Consulting Party Feedback

Re: Programmatic Agreement for Administration of the City of Louisville's Community Development Programs – Comments of the Miami Tribe of Oklahoma

Re: Beecher Terrace Housing Project Programmatic Agreement – Comments of the Miami Tribe of Oklahoma

Ref: *Proposed Beecher Terrace Redevelopment
City of Louisville, Kentucky*

EXISTING PARK
CONDITIONS

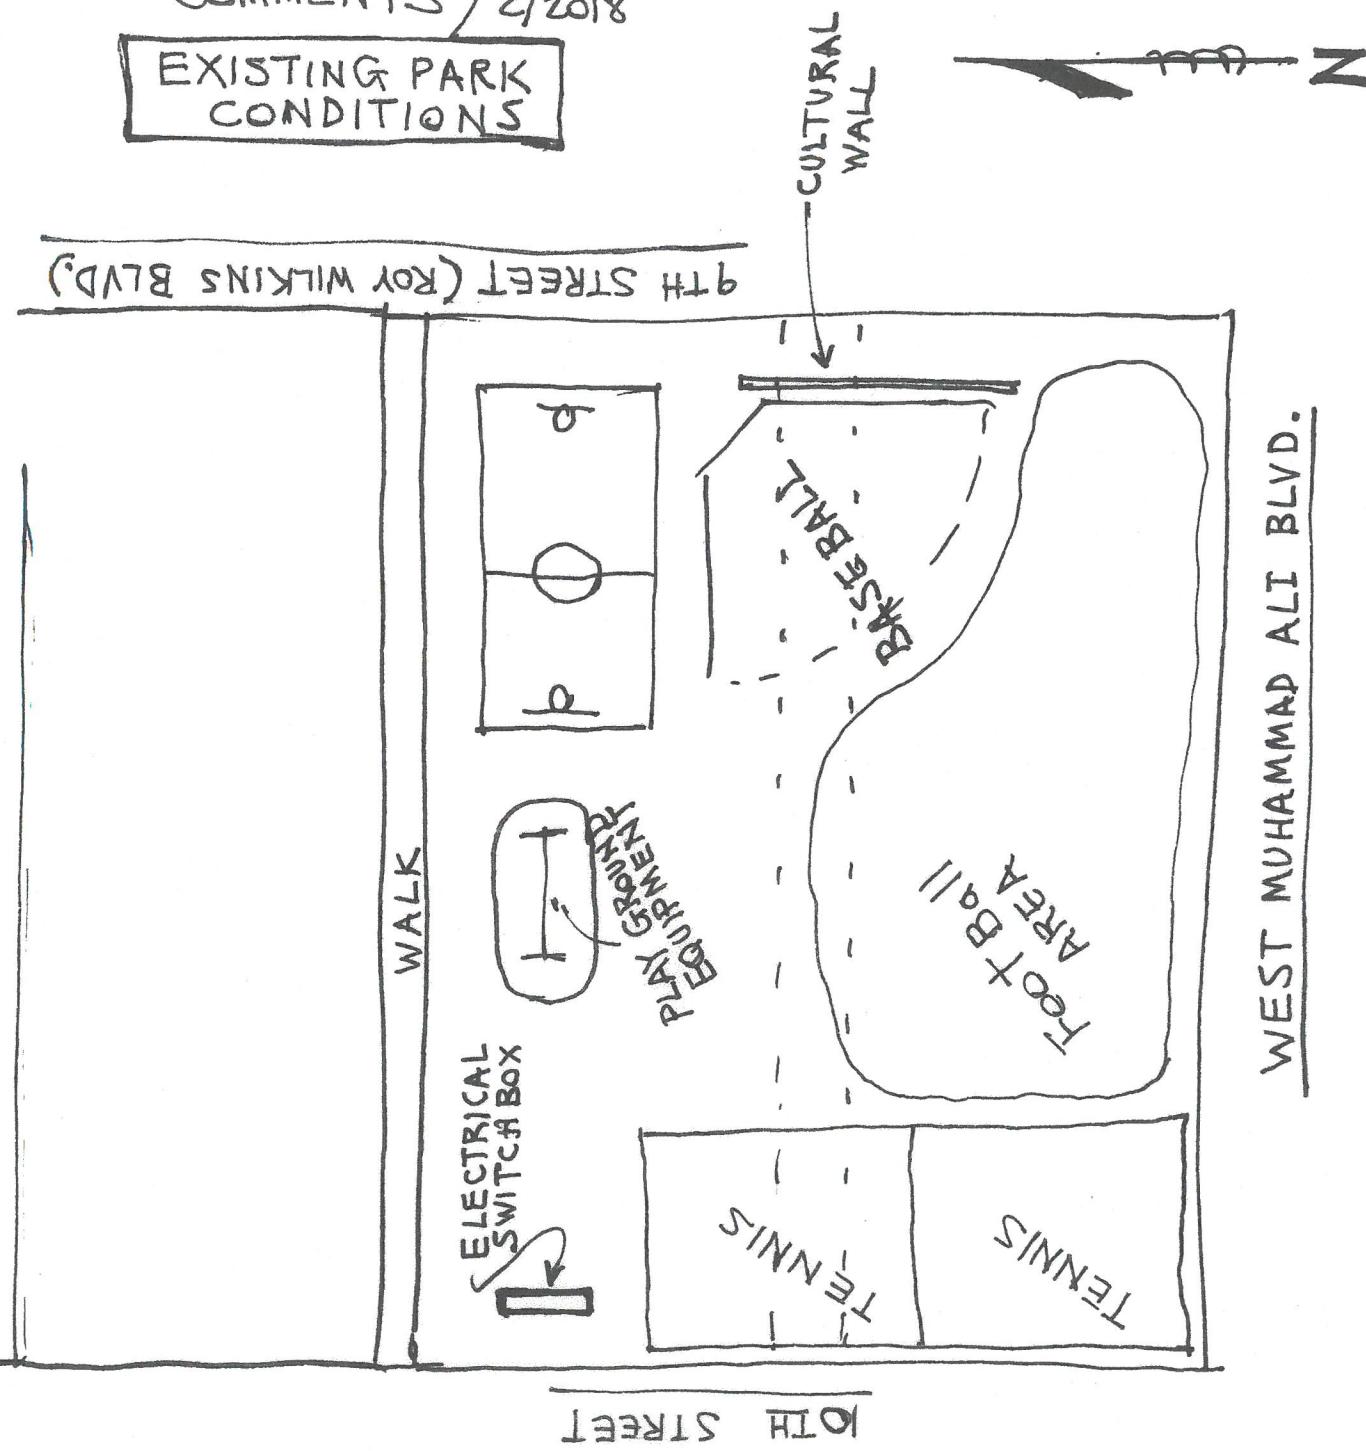
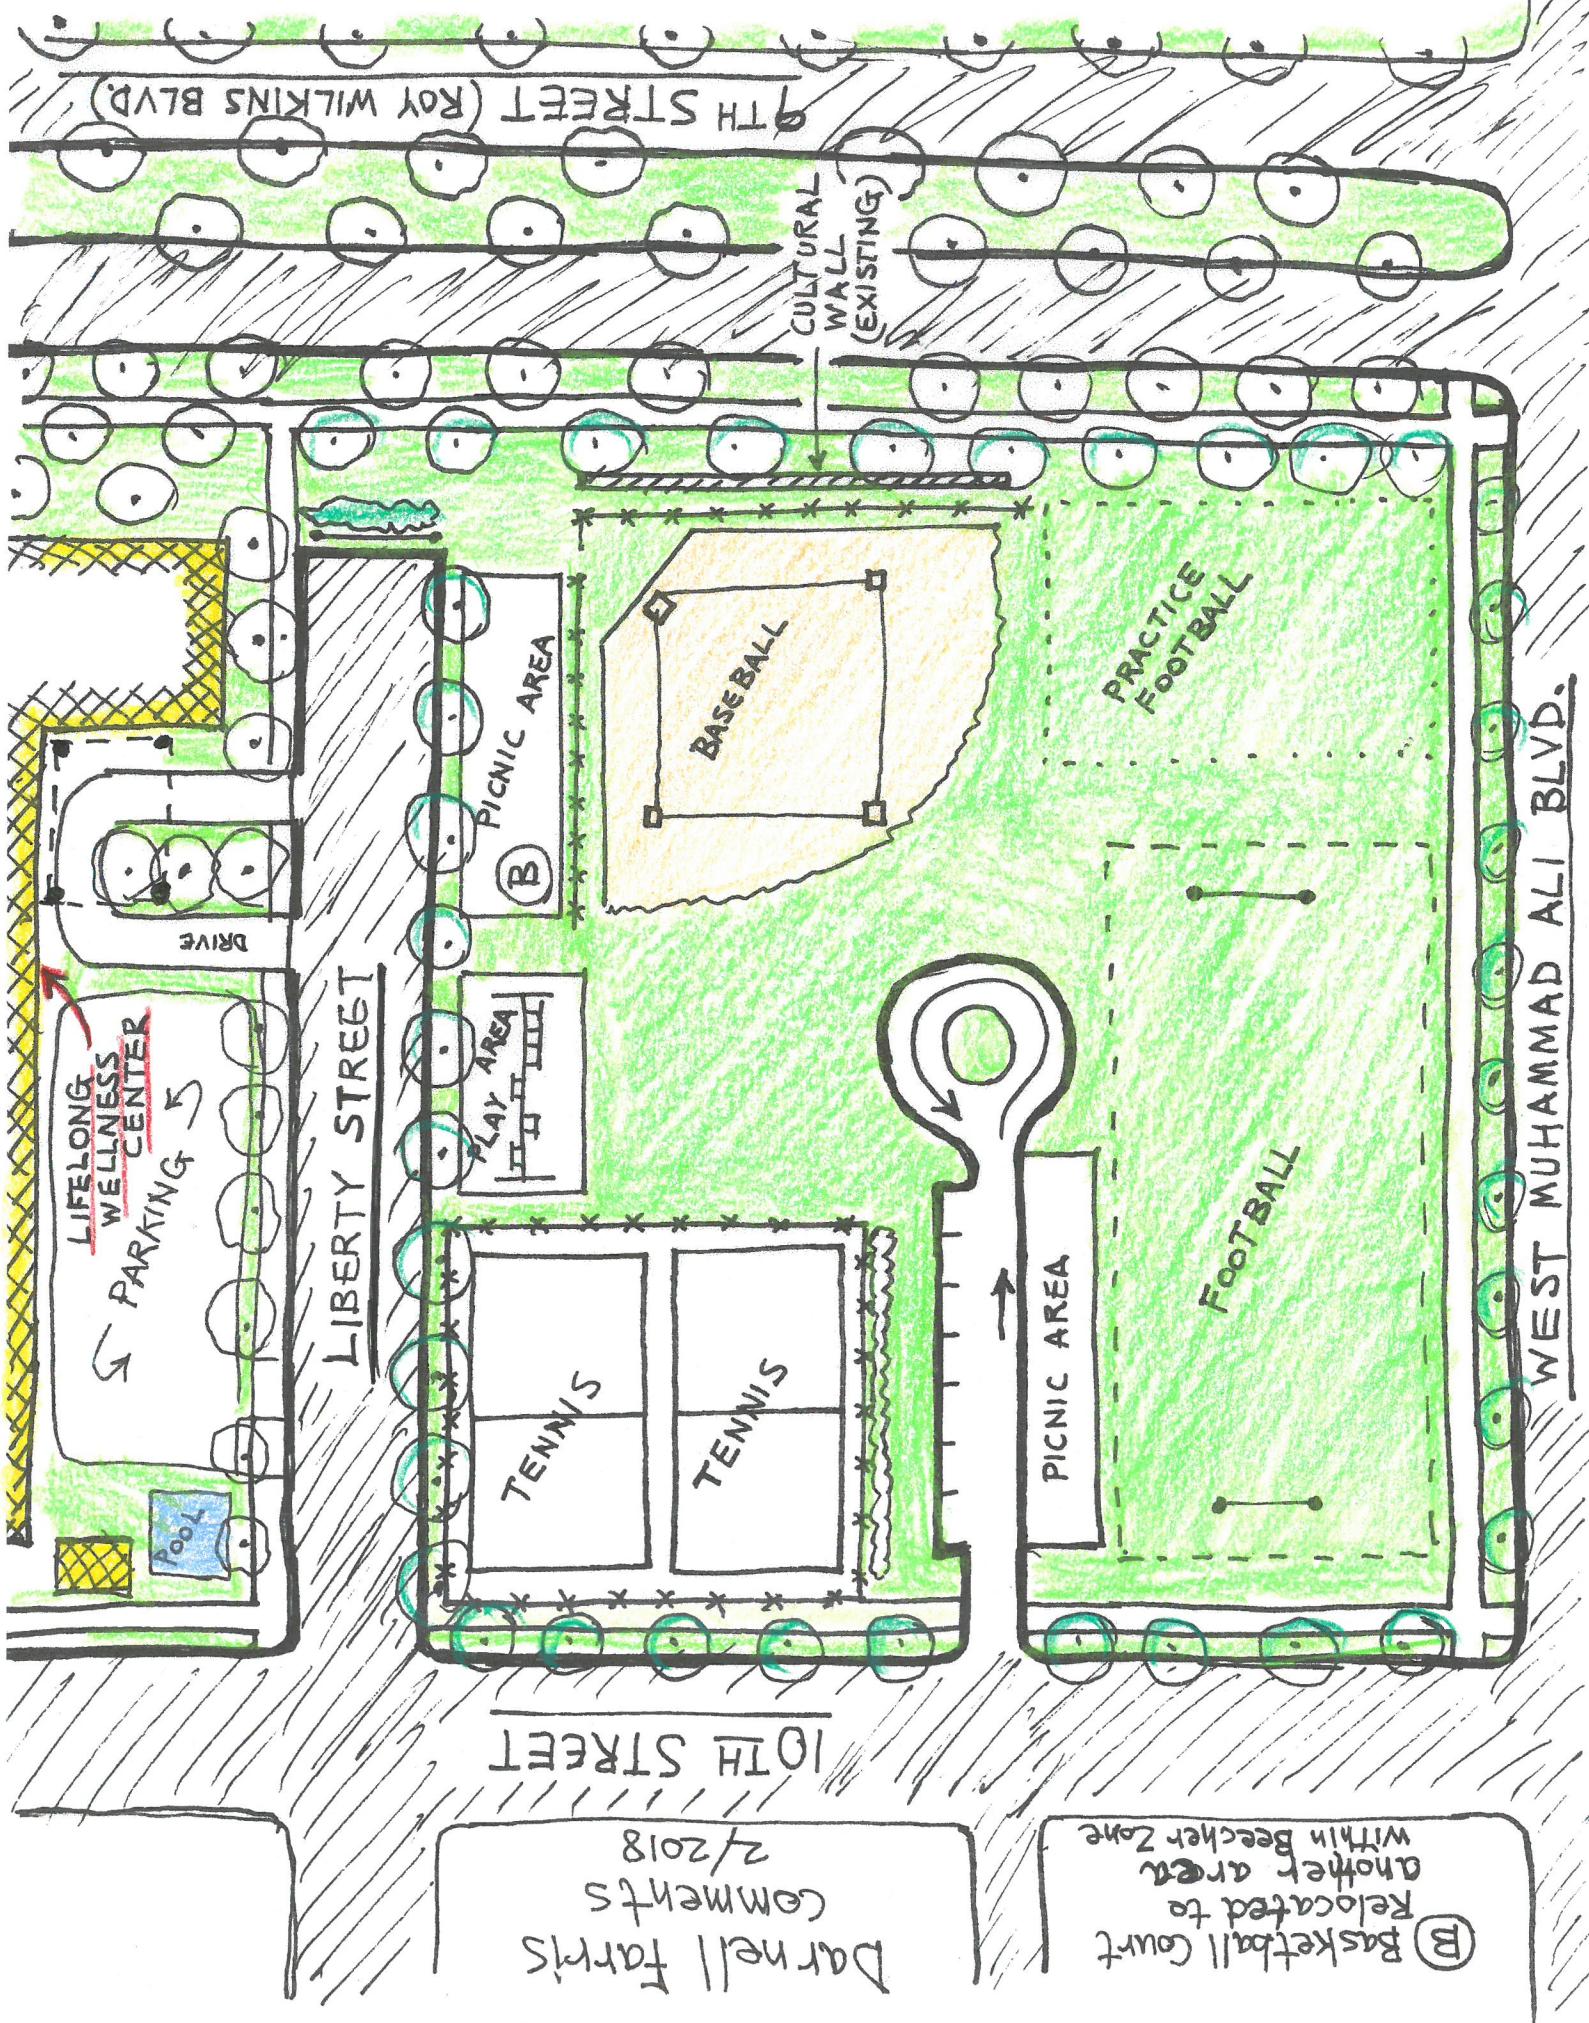
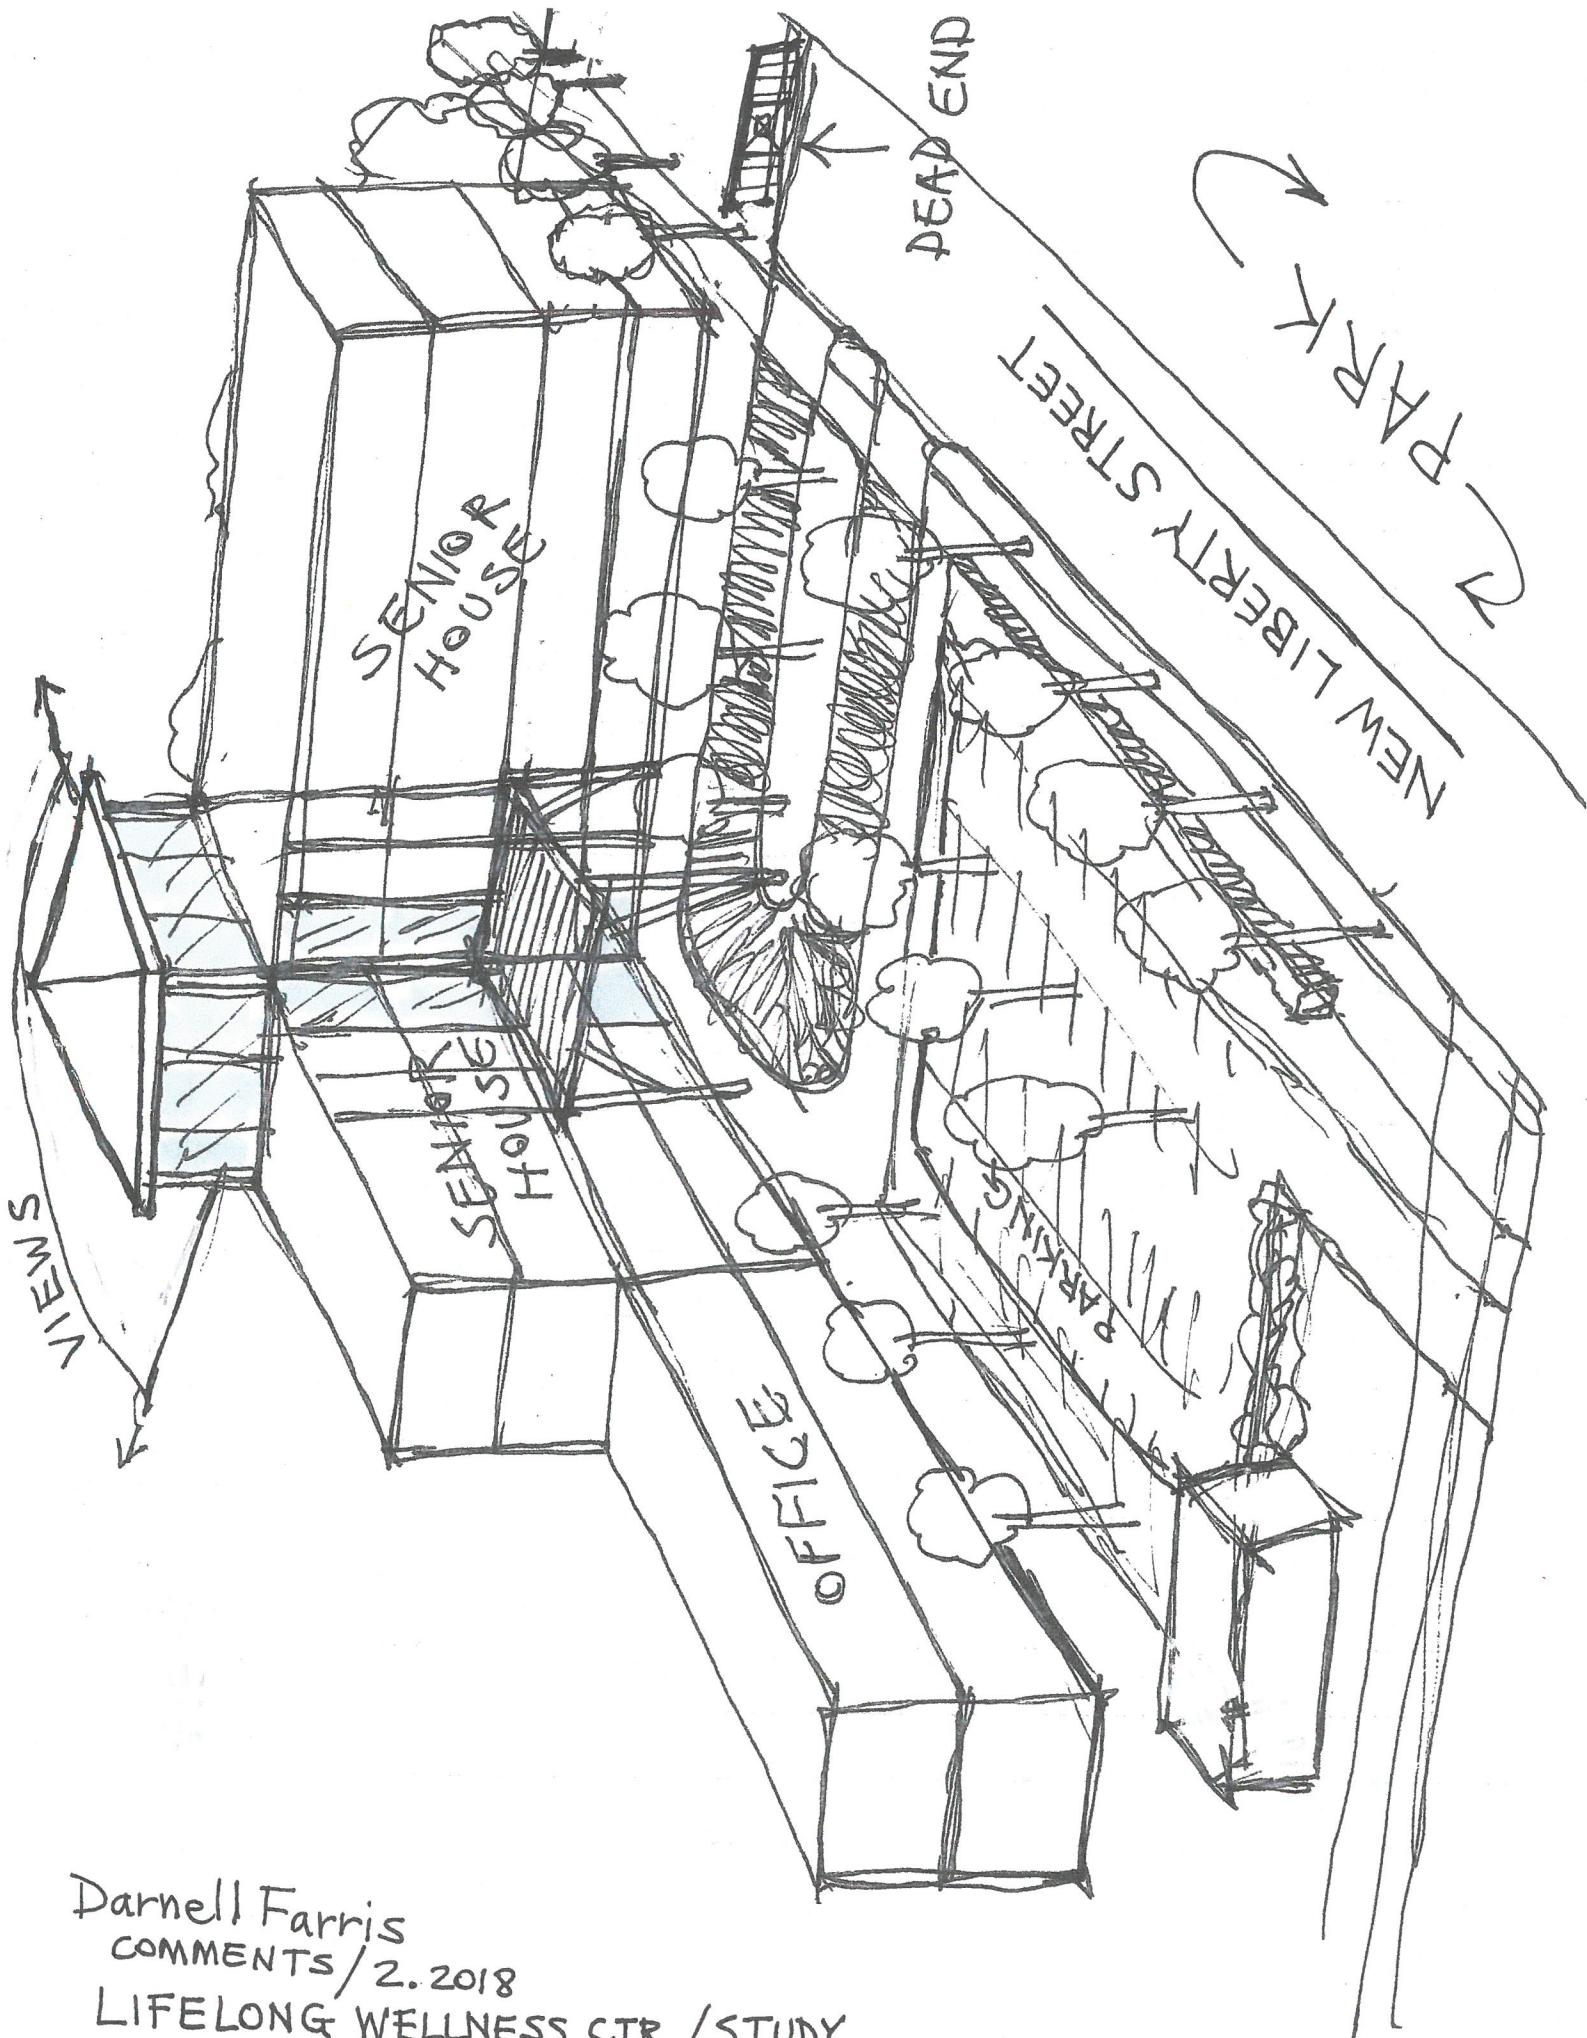
As part of the Beecher Terrace Revitalization plans submitted by Metro Louisville for consulting parties, I will comment on the following two (2) areas of development:
1. The Community Park at 9th & Roy Wilkins Avenue
2. The Lifelong Wellness Center

(See attached plan sketches)

Another long-term planning item as conceived by the last (2) Downtown Plans (Louisville Central Area), was that 9th street was to become a "Grand Blvd. of High Rise Housing." The current housing block is (aesthetics aside) boring, monolithic, and mis-directional. This structure should (in my mind), be a semi-hi-rise, with a shared emphasis to all points (especially downtown) - a tower lookout of sorts, incorporated in its design. I think the intended residents of this facility would love the amenity of sweeping views.

Lastly, the retention of every healthy tree (and inclusion of new ones) should be a major priority for this park & the 9th street corridor.
